ADDENDUM NUMBER: 5
PROJECT: **UNC Charlotte Residence Hall Phase XIV - Early Site Packages**

DATE: **March 4, 2015**
OWNER: **UNC Charlotte**
ARCHITECT: **FWA Group**

Early Site Package Pre-Bid RFI #1

Early Site Package Pre-Bid RFI #2

FLOOR FRAMING DETAILS

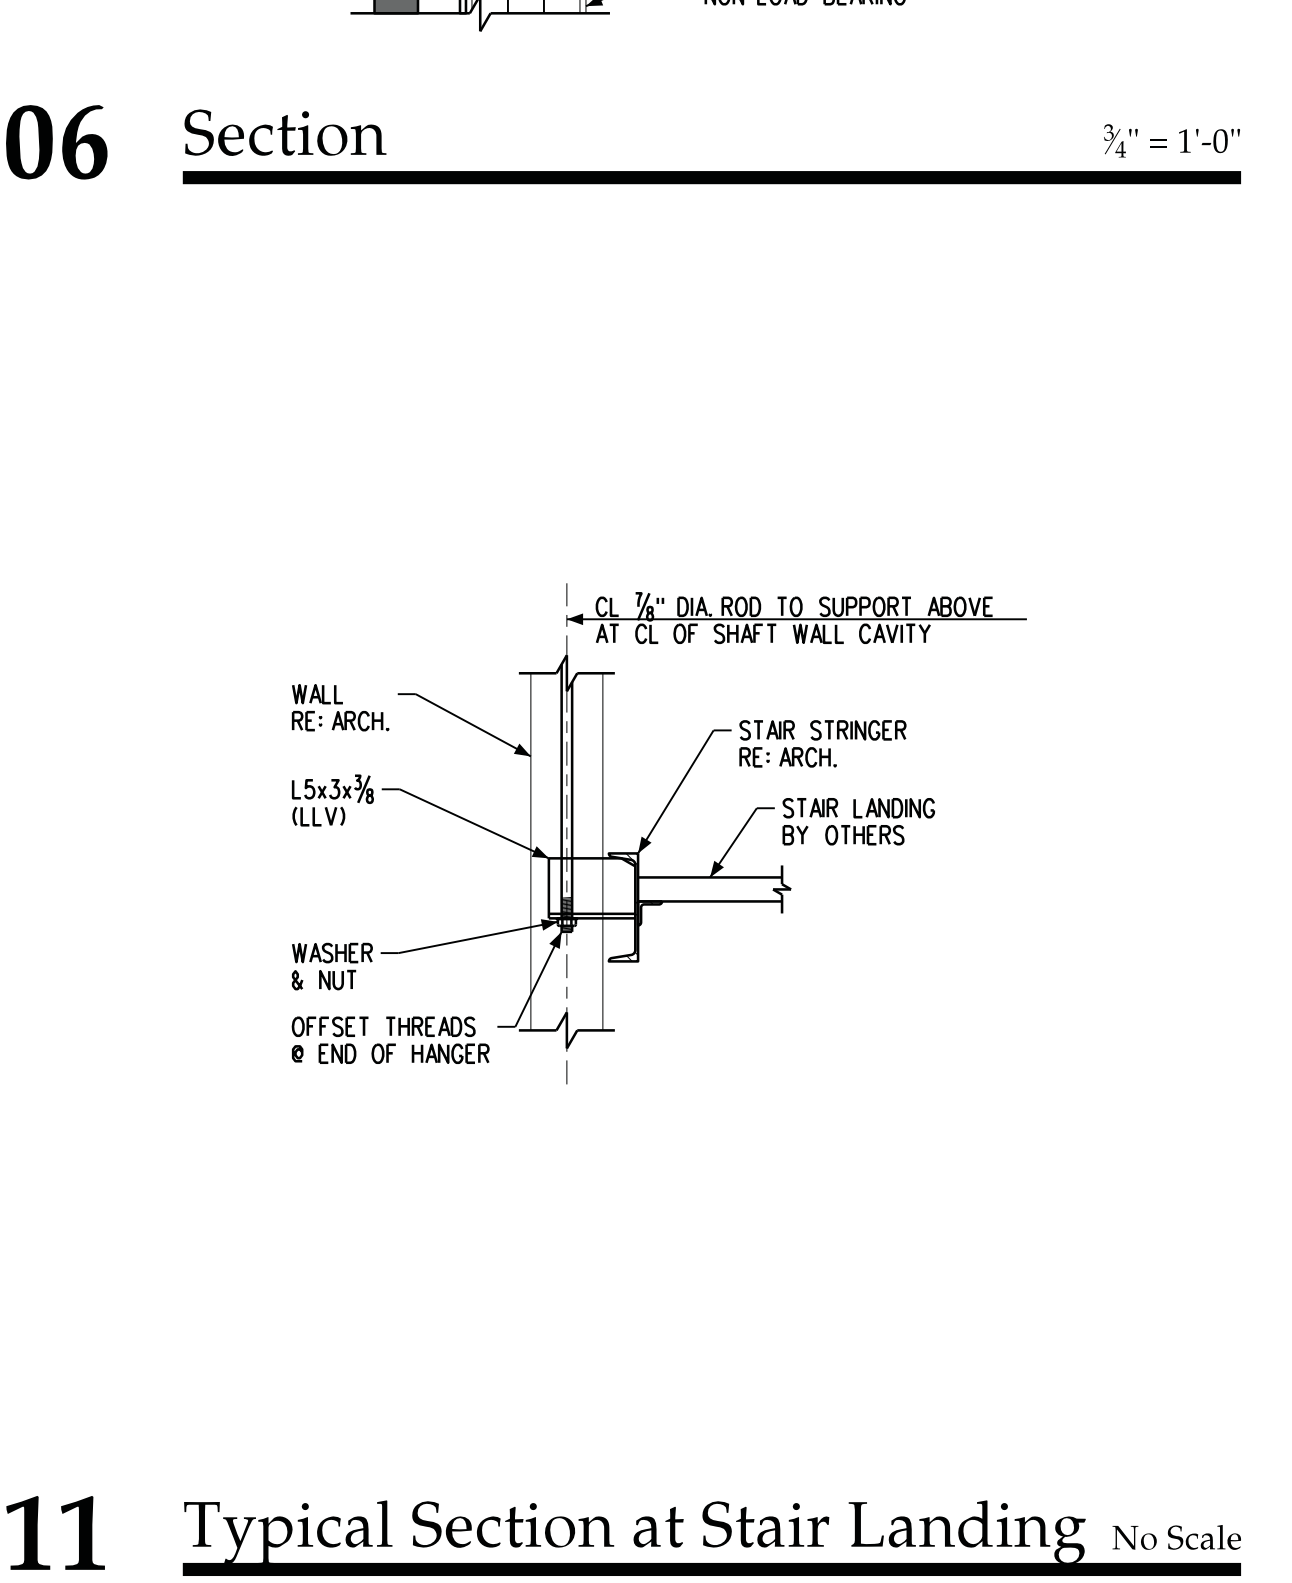
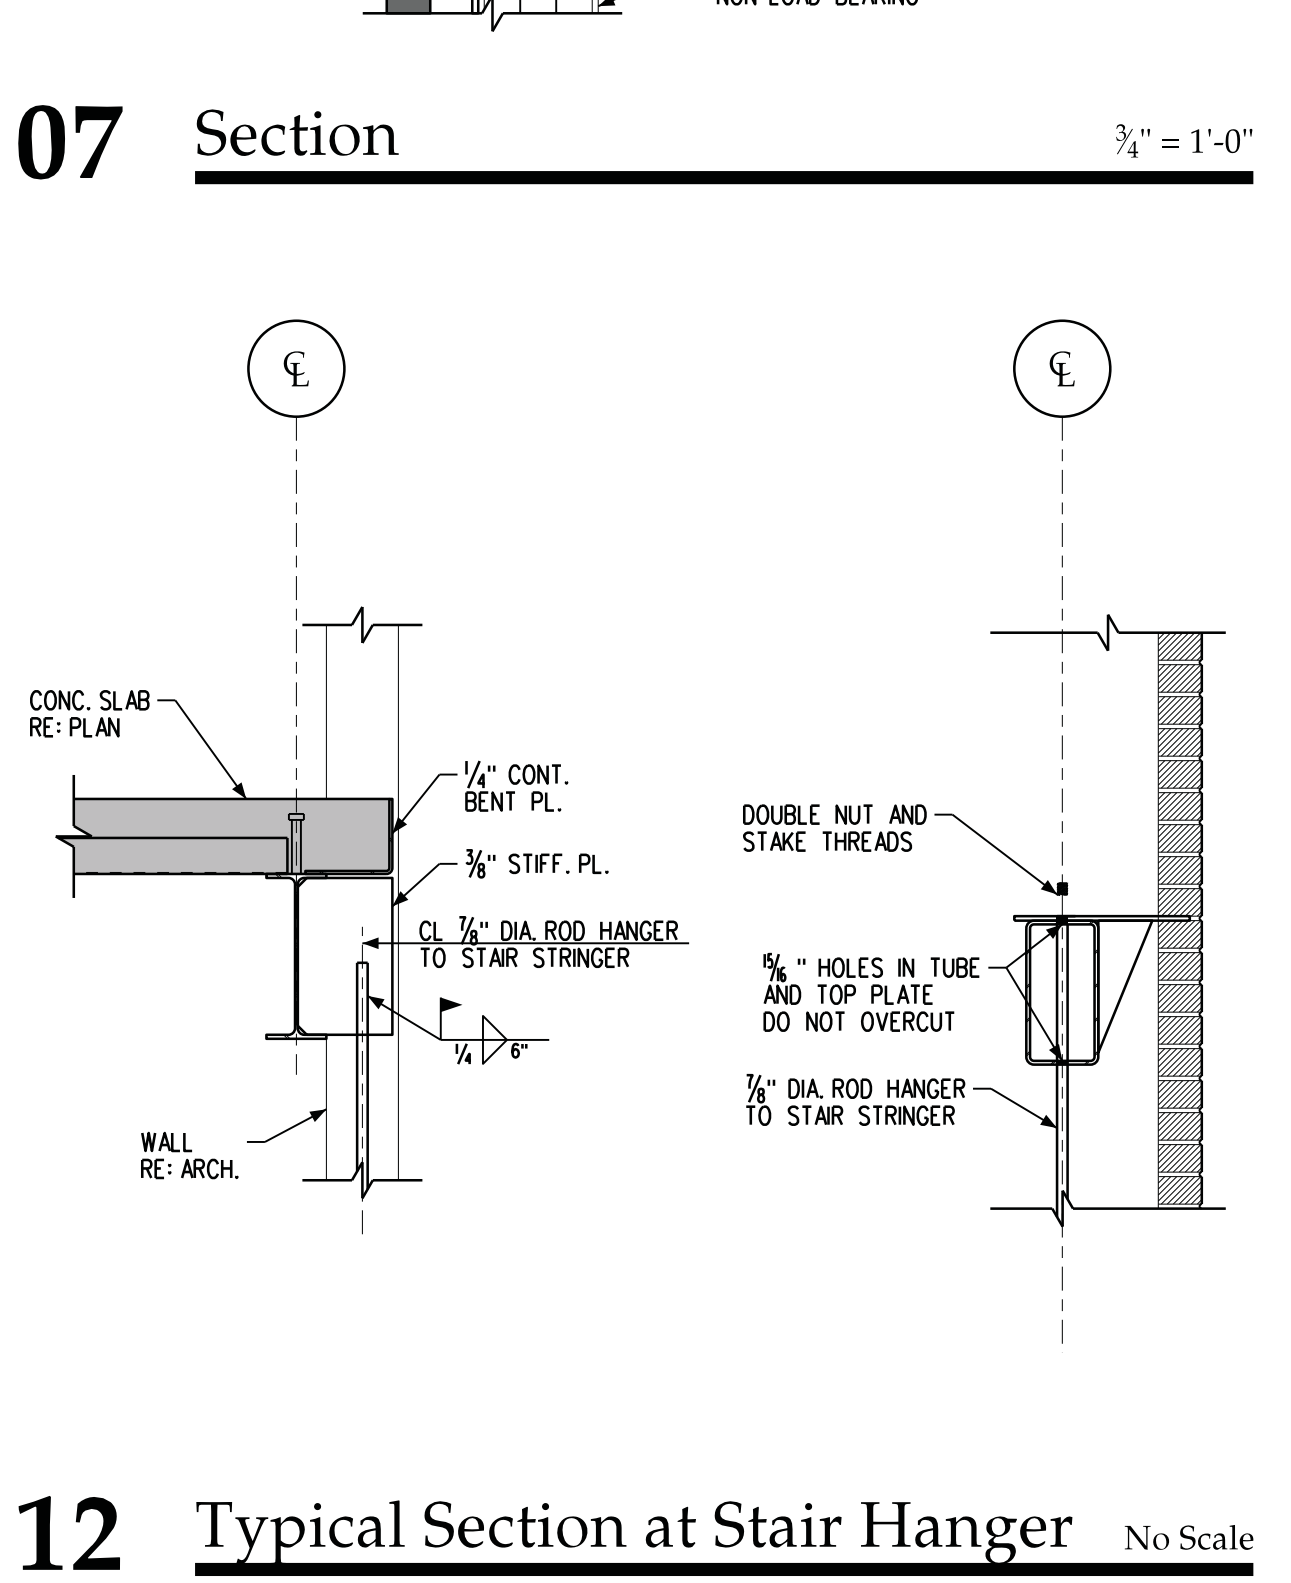
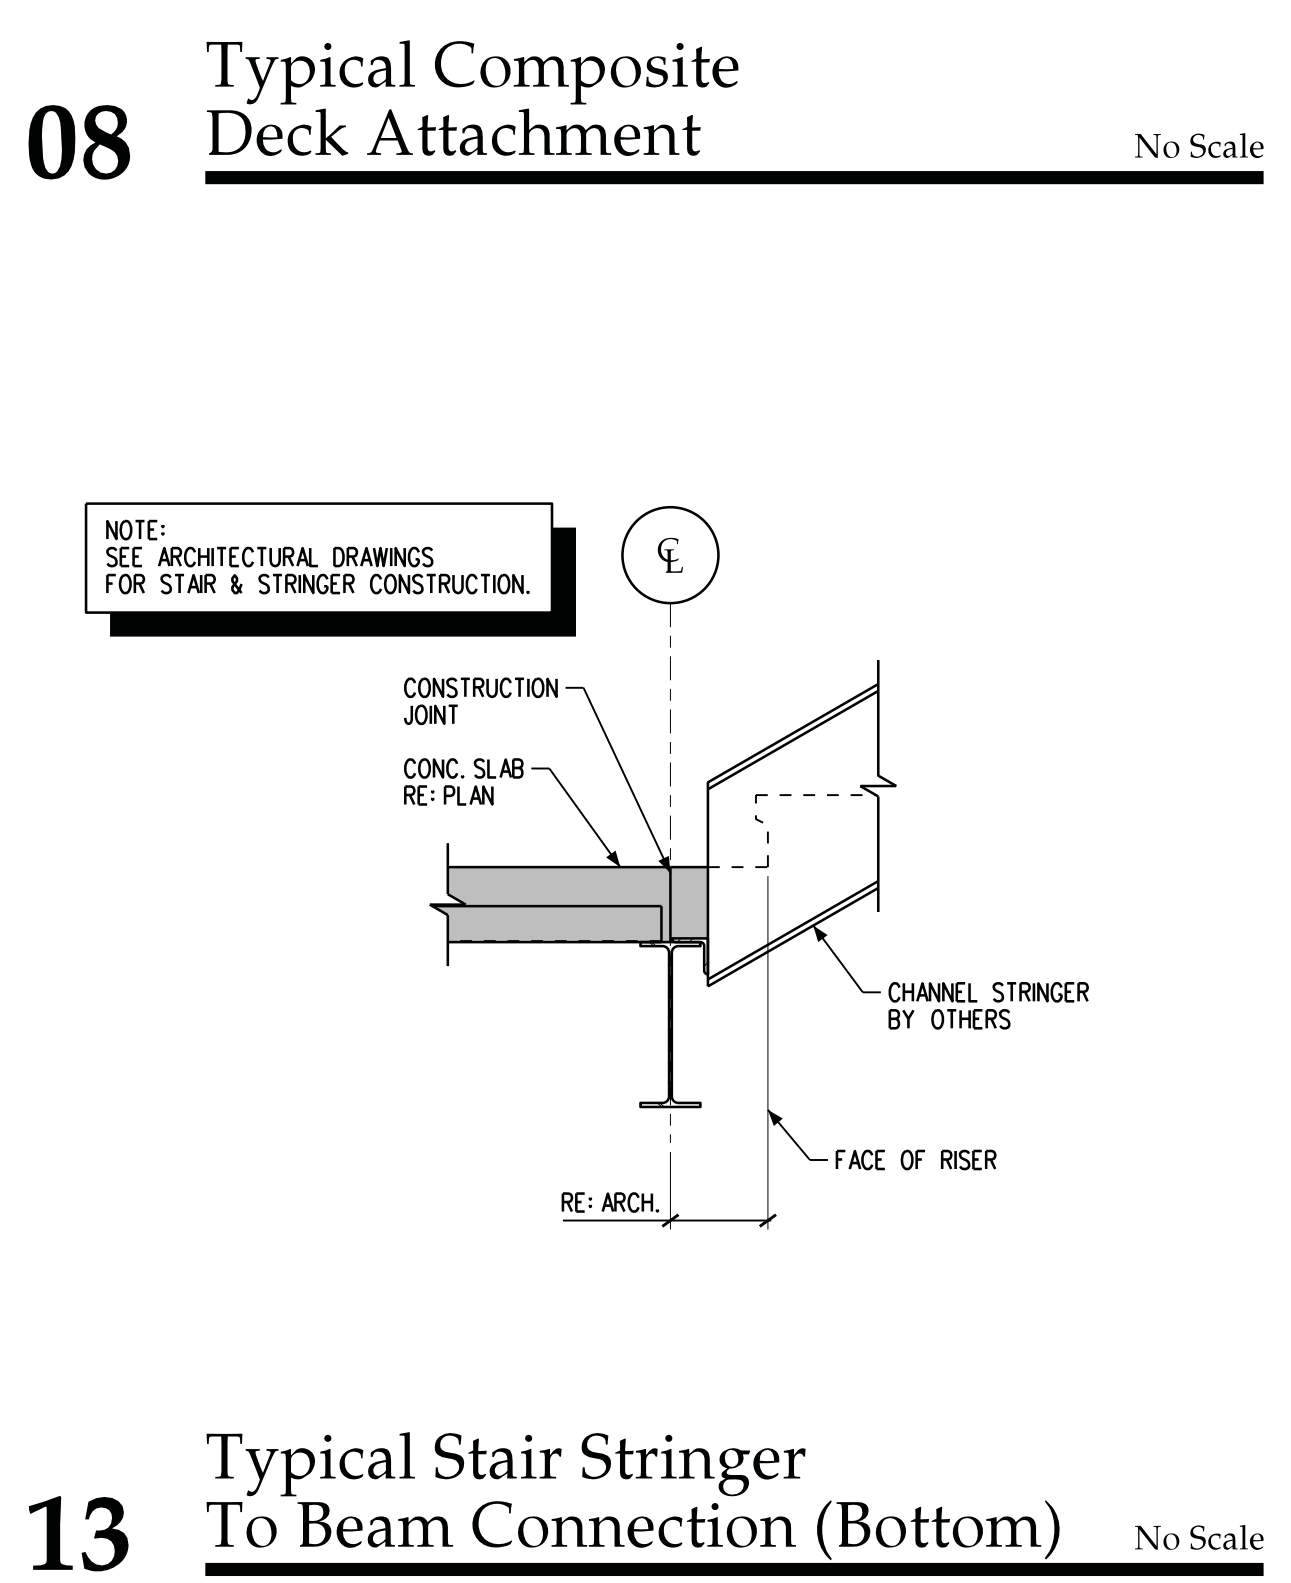
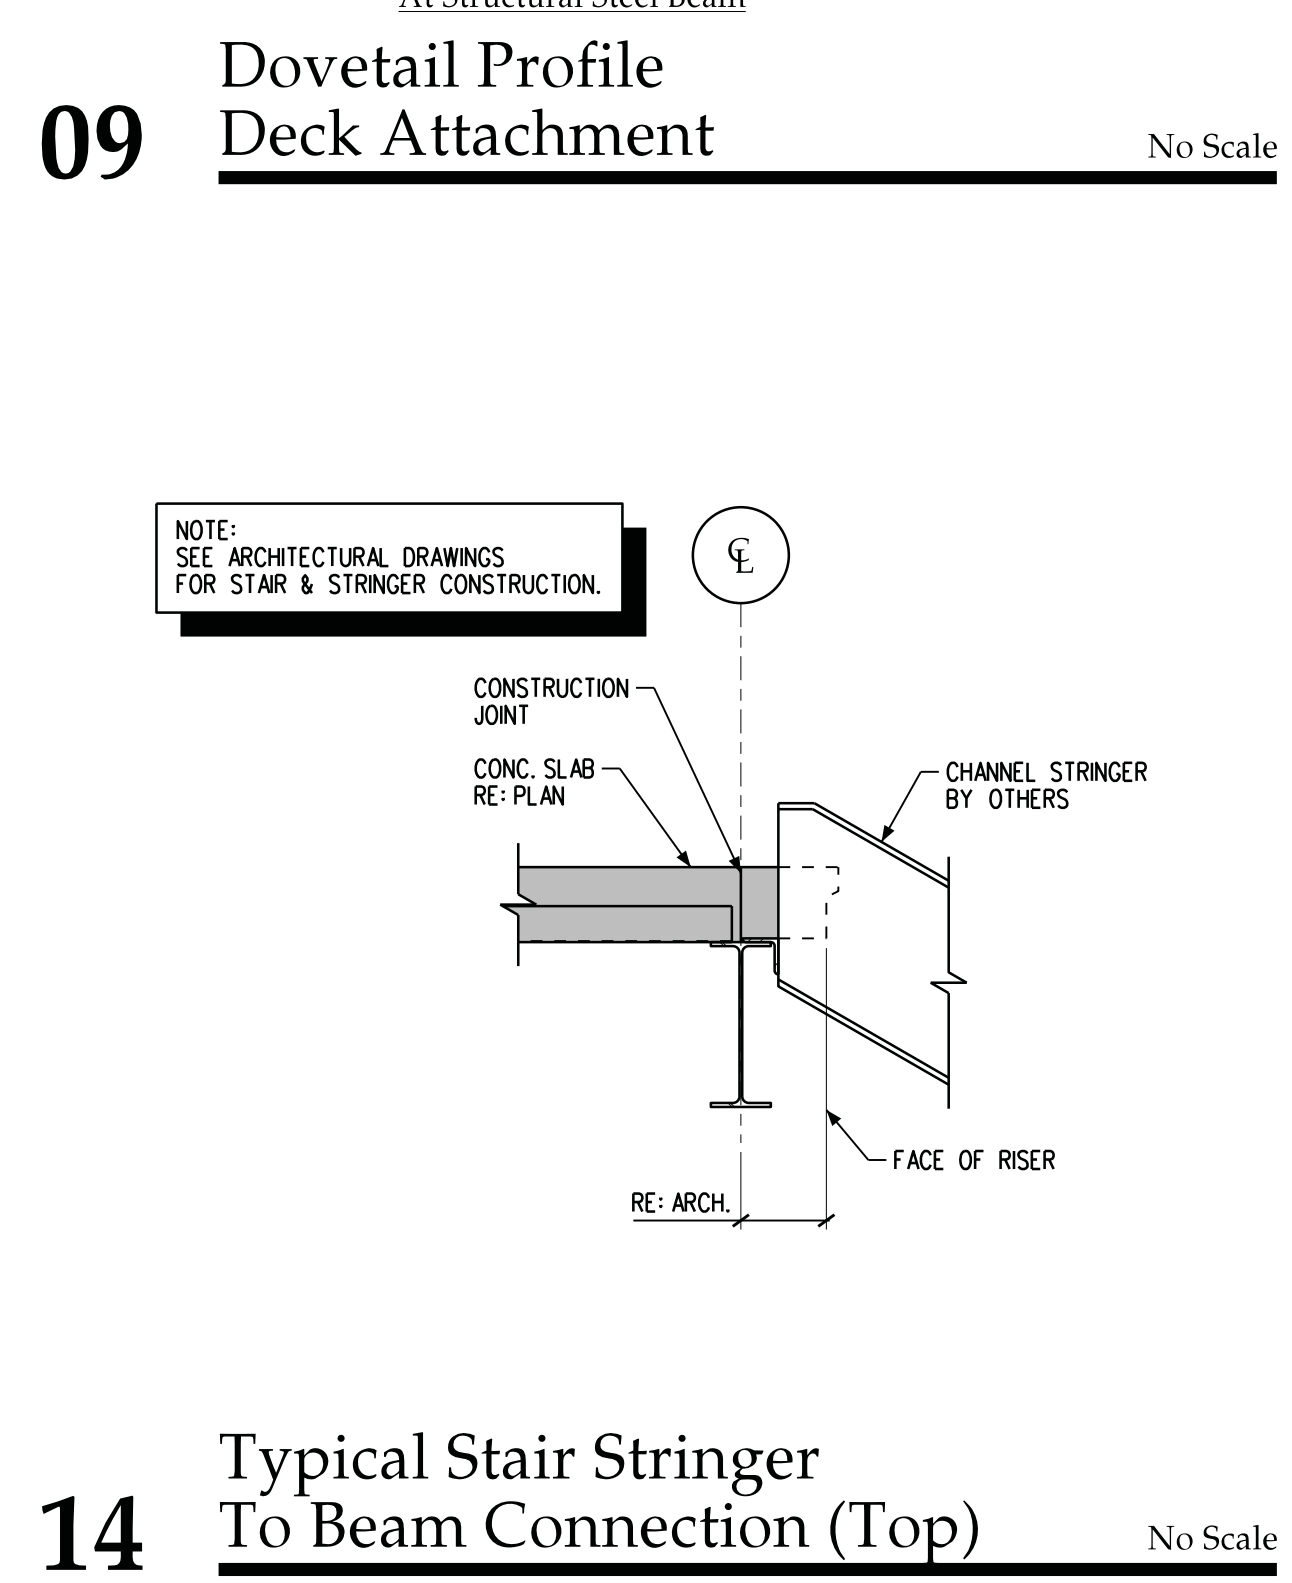
Answer:	BSDE Response: Typical slabs <u>over structural steel framing</u> do not require WWF. However, construction joints in slabs do utilize WWF as detailed on 03/S402. NOTE: Elevated slabs supported by CFS framing (using dovetail deck) DO REQUIRE WWF as indicated. We have removed the WWF depiction from details 03, 04, 06, 07, 10, & 15 on S401. The WWF in detail 01/S401 is correct. See FWA Addendum #02.
24	Section 2/S303 at 27 & 28 line on sheets 203-N, 204-N, and 205-N does not appear to be correct. Please verify call out.

Answer:	BSDE Response: The reference has been revised to read 02/S401 at these locations. See FWA Addendum #02.
25	Detail 5/S403- please verify shear wall anchor welded to steel are by 05A
